PIC16C715

PIC16C715 Data Sheet Errata

The PIC16C715 parts you have received conform functionally to the Device Data Sheet (DS30272A), except for the anomalies described below.

18-Lead Plastic Dual In-line (P) – 300 mil (PDIP)

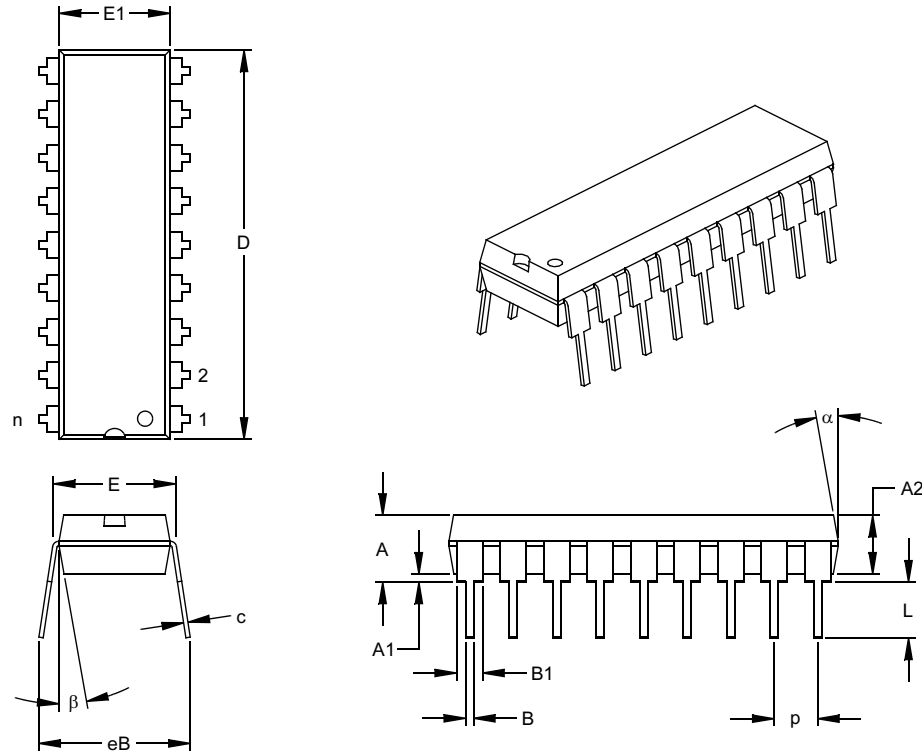
4. Module: Packaging

The package information contained in the data sheet is incorrect. Please refer to the following tables for correct package data.

Units		INCHES*			MILLIMETERS		
Dimension Limits		MIN	NOM	MAX	MIN	NOM	MAX
Number of Pins	n		18			18	
Pitch	p		.100			2.54	
Top to Seating Plane	A	.140	.155	.170	3.56	3.94	4.32
Molded Package Thickness	A2	.115	.130	.145	2.92	3.30	3.68
Base to Seating Plane	A1	.015			0.38		
Shoulder to Shoulder Width	E	.300	.313	.325	7.62	7.94	8.26
Molded Package Width	E1	.240	.250	.260	6.10	6.35	6.60
Overall Length	D	.890	.898	.905	22.61	22.80	22.99
Tip to Seating Plane	L	.125	.130	.135	3.18	3.30	3.43
Lead Thickness	c	.008	.012	.015	0.20	0.29	0.38
Upper Lead Width	B1	.045	.058	.070	1.14	1.46	1.78
Lower Lead Width	B	.014	.018	.022	0.36	0.46	0.56
Overall Row Spacing	§ eB	.310	.370	.430	7.87	9.40	10.92
Mold Draft Angle Top	α	5	10	15	5	10	15
Mold Draft Angle Bottom	β	5	10	15	5	10	15

Dimensions D and E1 do not include mold flash or protrusions. Mold flash or protrusions shall not exceed .010" (0.254mm) per side.
